LEAK TL12, UL or TRIODE

Revised march 2005 turneraudio.com.au april 2006

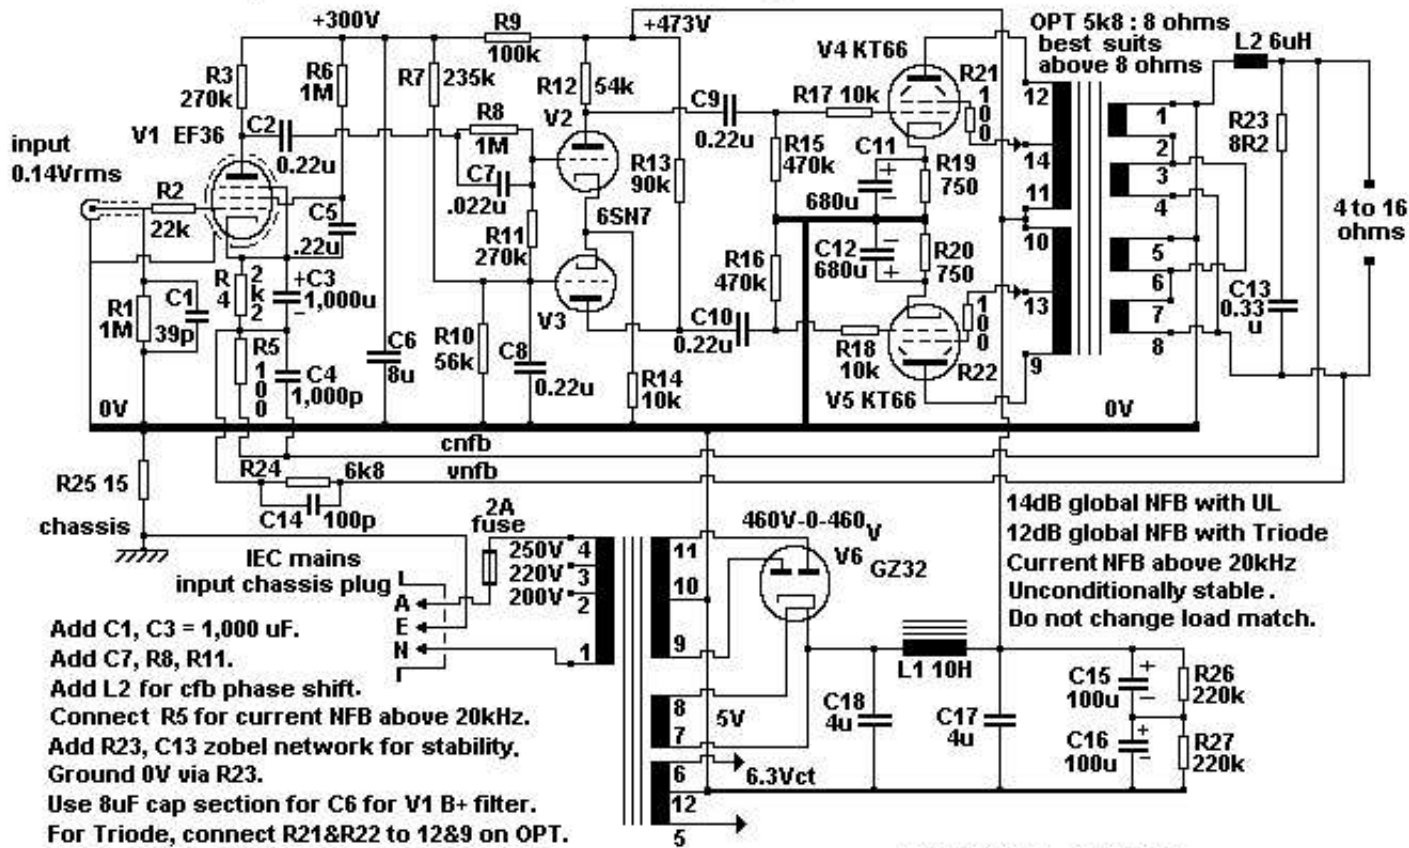
Component numbers are not the same as for original 1954 Leak schematic.

- Add C1, C3 = 1,000 uF.
- Add C7, R8, R11.
- Add L2 for cfb phase shift.
- Connect R5 for current NFB above 20kHz.
- Add R23, C13 zobel network for stability.
- Ground 0V via R23.
- Use 8uF cap section for C6 for V1 B+ filter.
- For Triode, connect R21&R22 to 12&9 on OPT.
- Revise biasing V2&V3 with R7, R10, C8, R14.
- R3 changed to 270k.
